CITY OF SOUTHGATE PLANNING COMMISSION AGENDA

PROPOSED NEW - GAS STATION

Carlisle | Wortman
ASSOCIATES, INC.

Special Condition and Site Plan Review

Sheet Title:
DETAILS

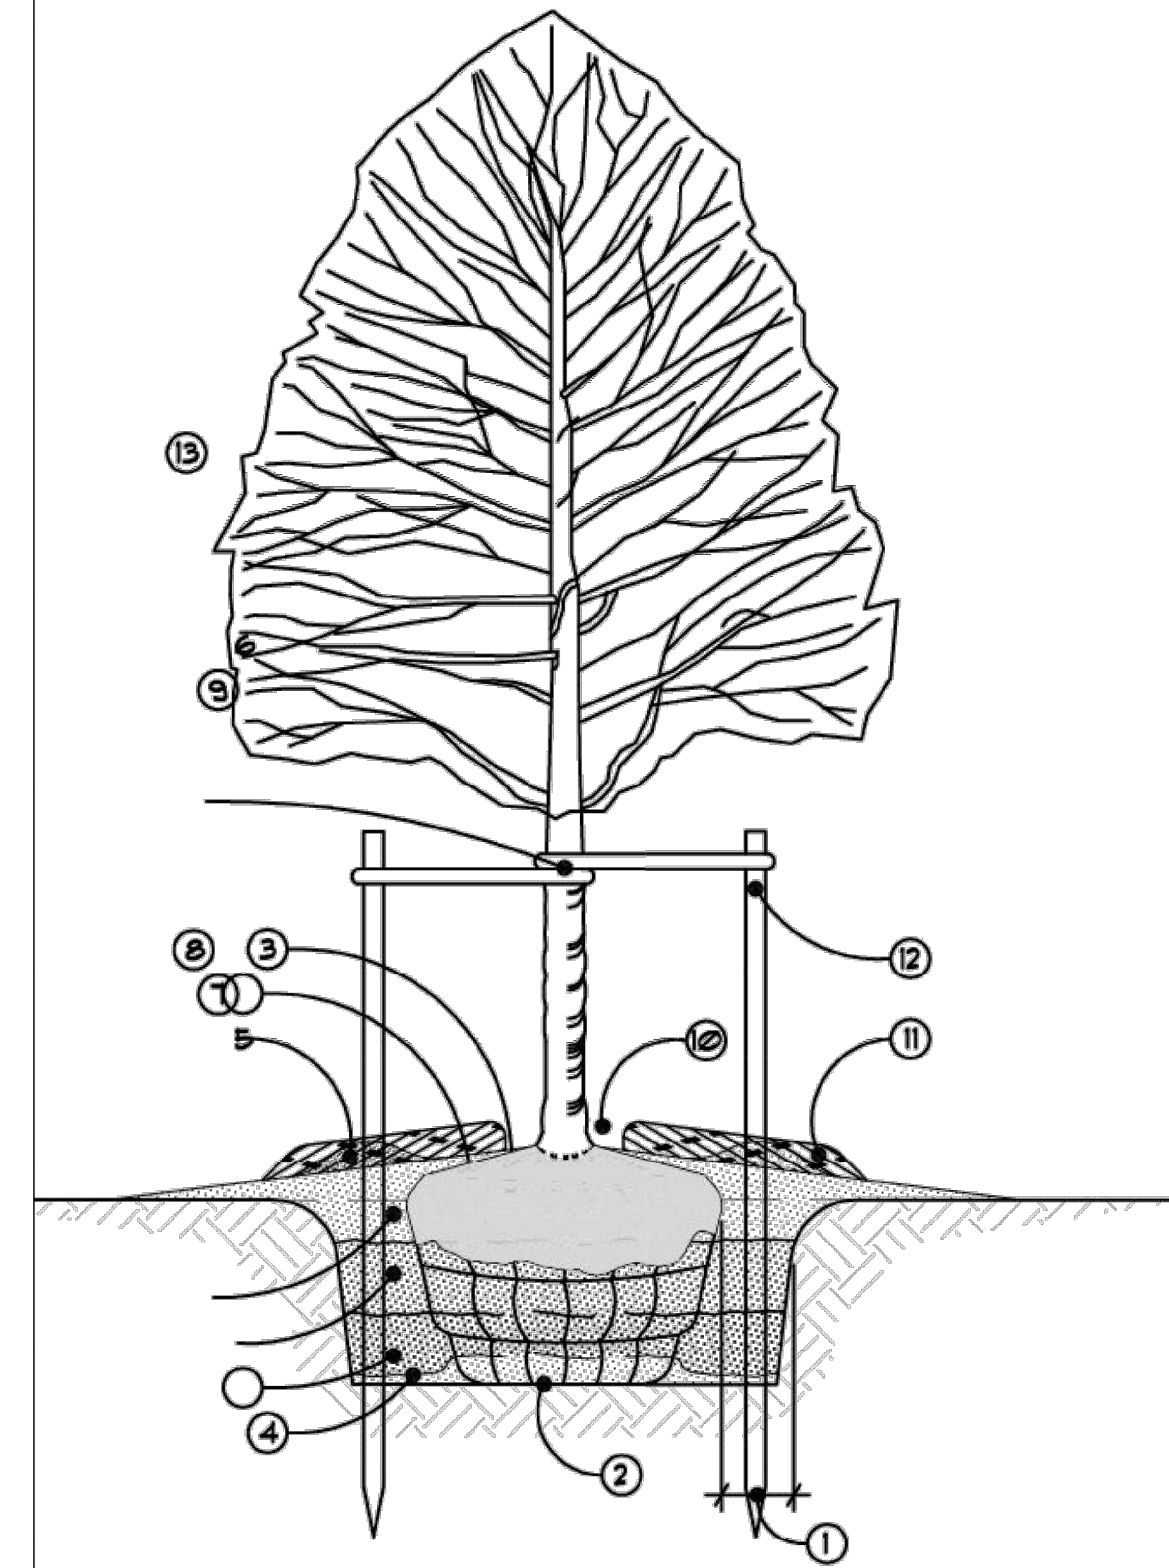
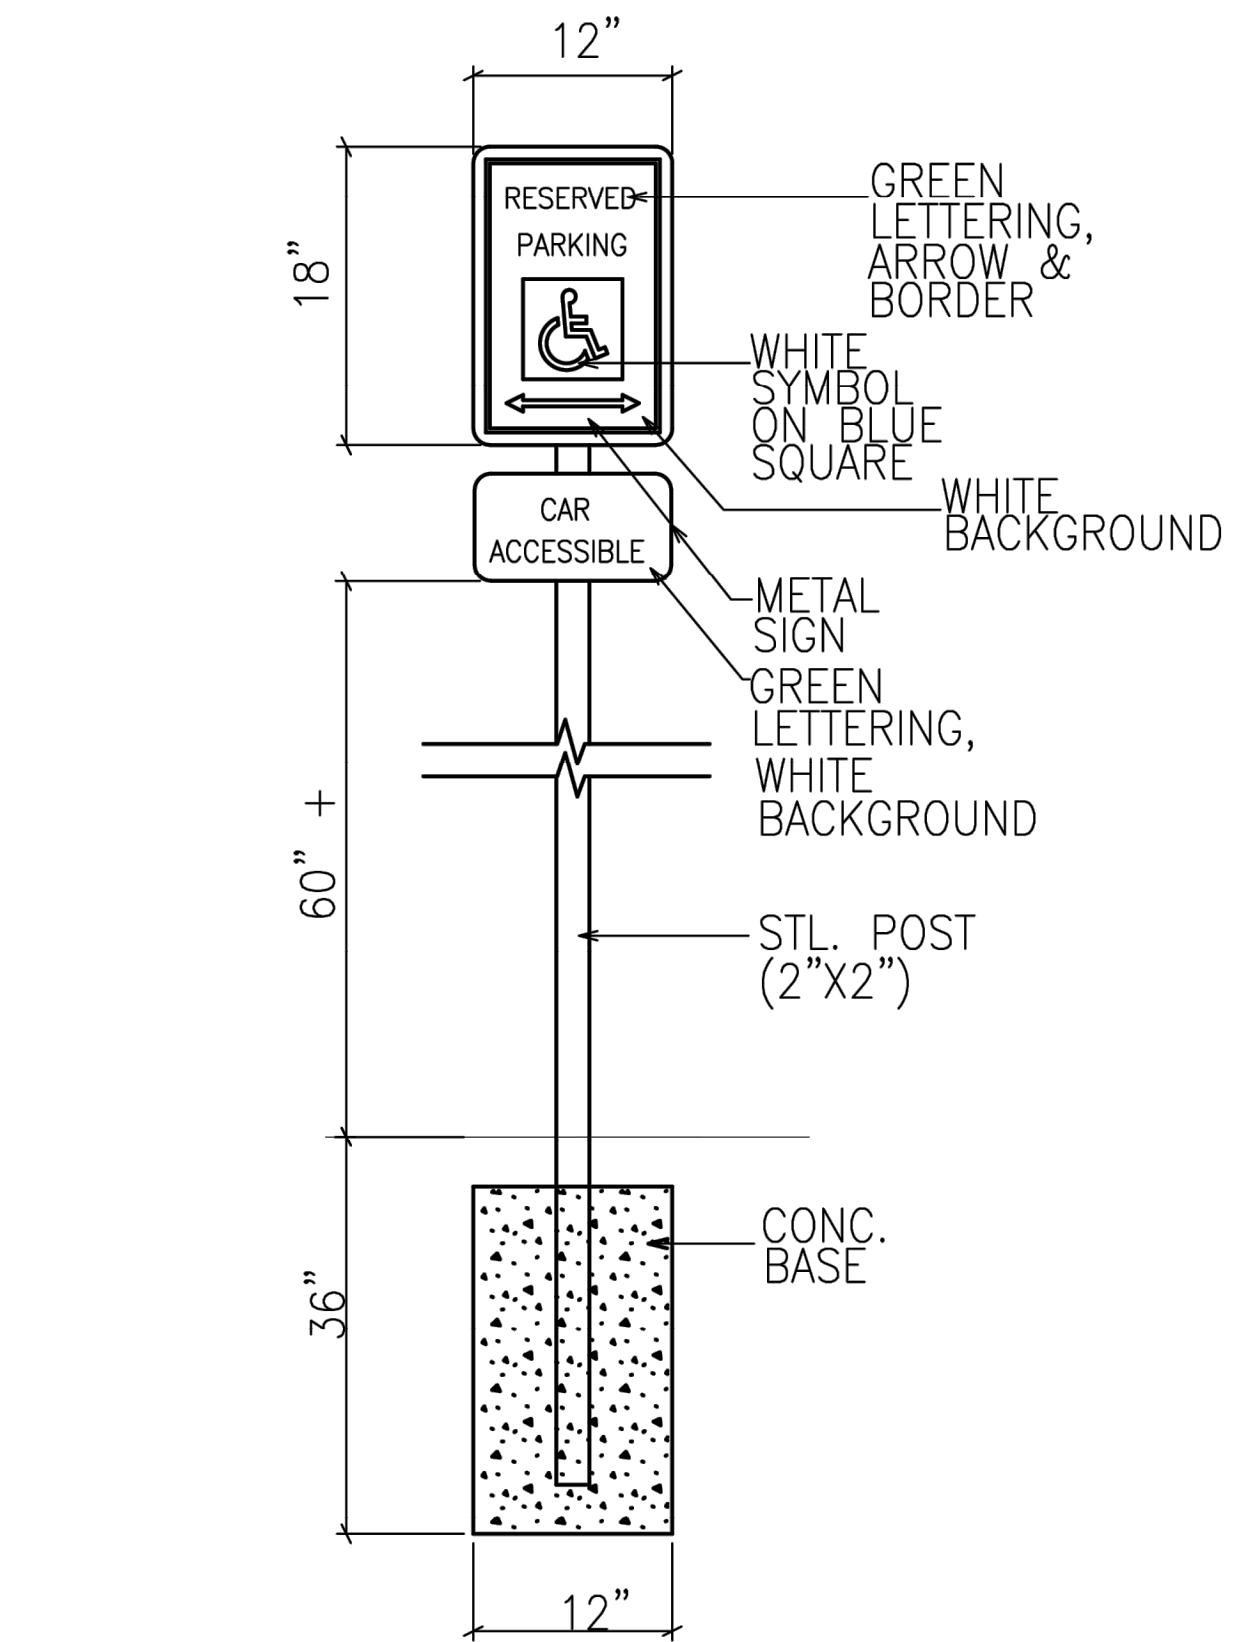
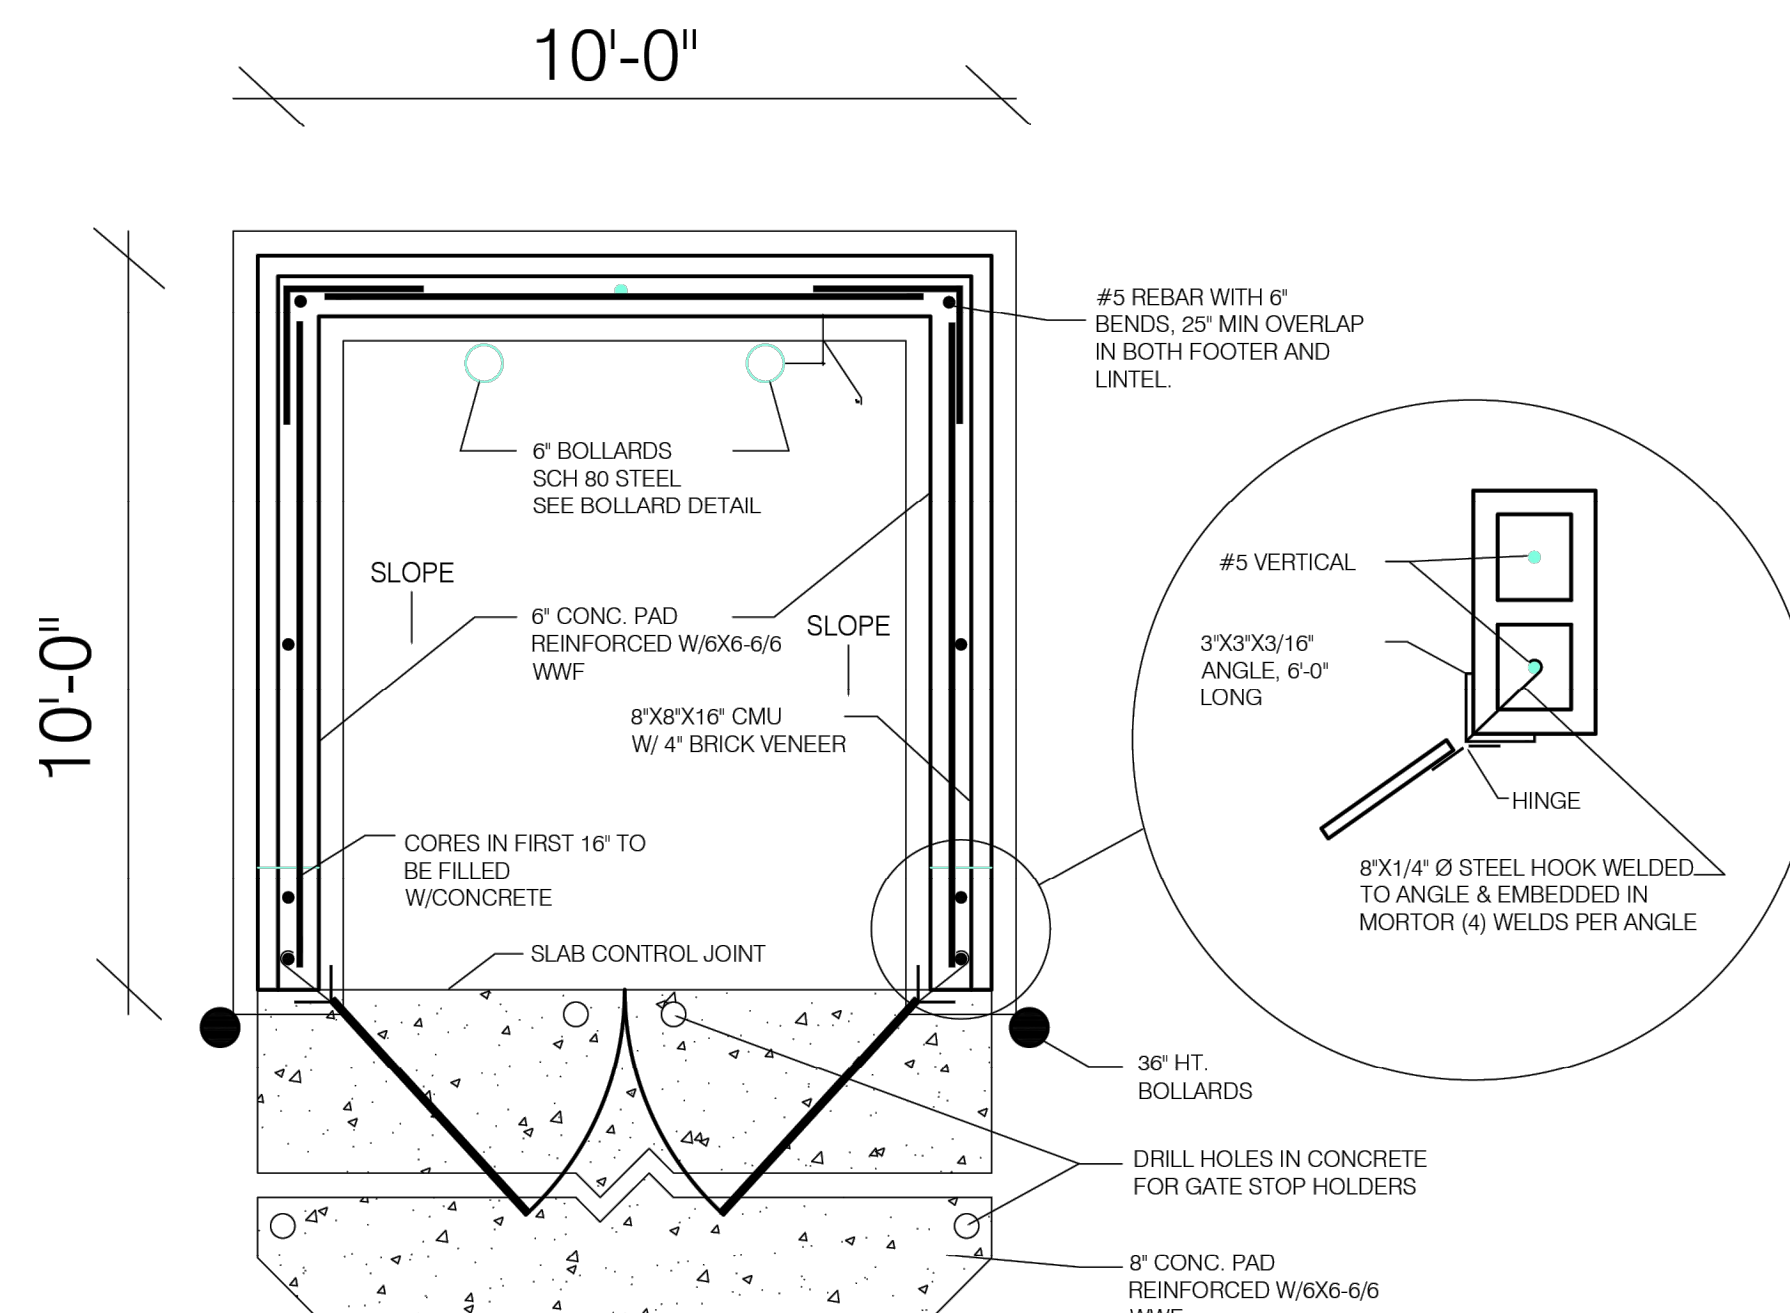
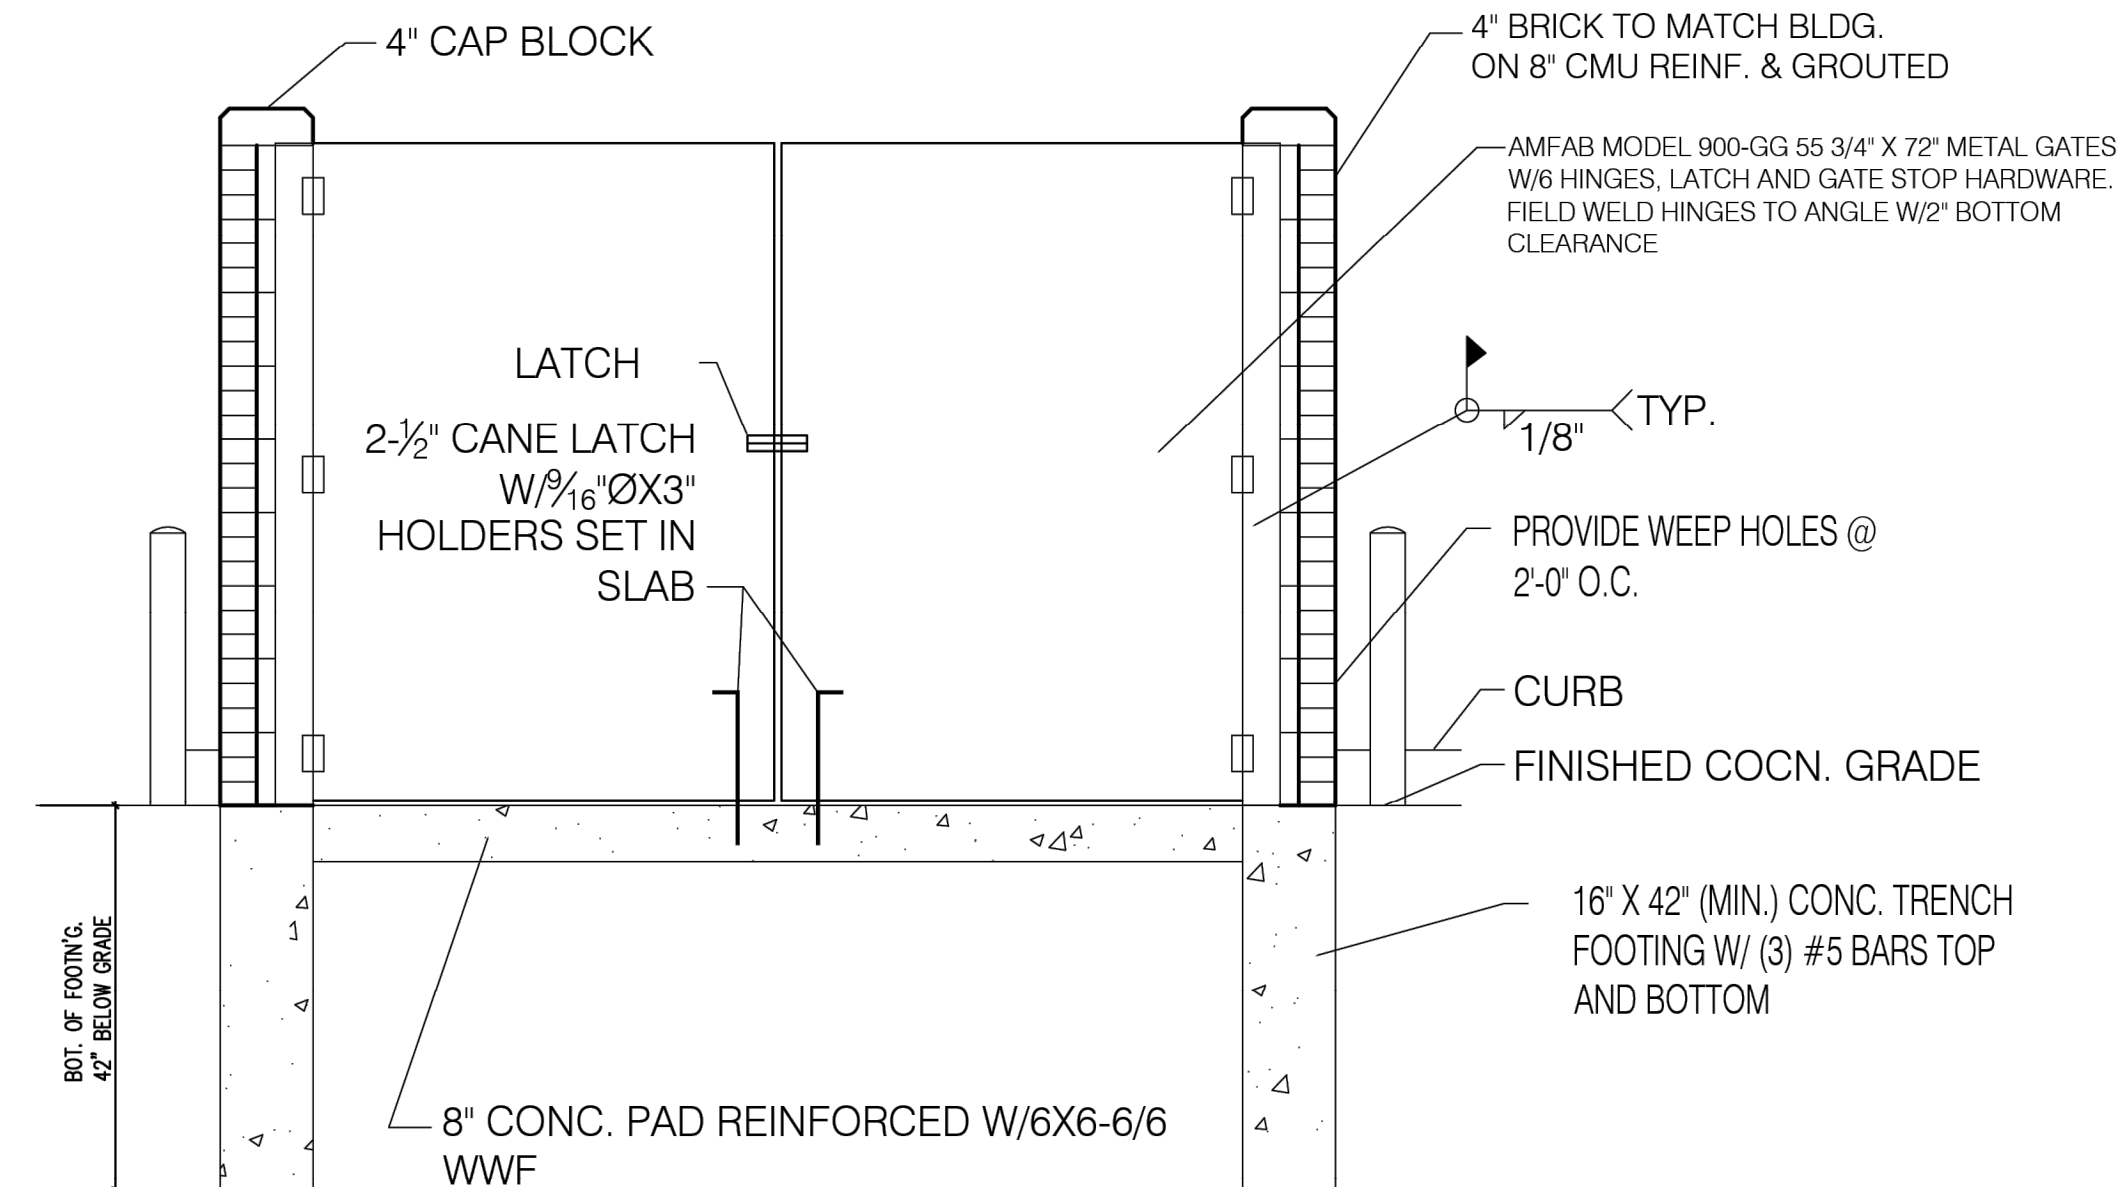
A landscape plan has been provided on sheet SP-102, with details on sheet SP-103. We do note on sheet SP-103, note 1, there is mention of compliance for Northville, Michigan. This will need to be revised to the City of Southgate.

Per section 1298.09, a landscape plan shall also consist of planting cross-section details, planting size, and spacing dimensions, which are provided on the current landscape plan on sheet SP-103 except for a shrub detail which should be provided. Planting symbols, quantities, size, and spacing information are provided. While the minimum ordinance requirements for shrub spacing is three (3) feet, we are of the opinion that the current spacing of two (2) feet is adequate after consultation with a landscape architect.

Items to be Addressed: 1) Change note #1 from “Northville” to “Southgate” 2) Provide shrub planting detail.
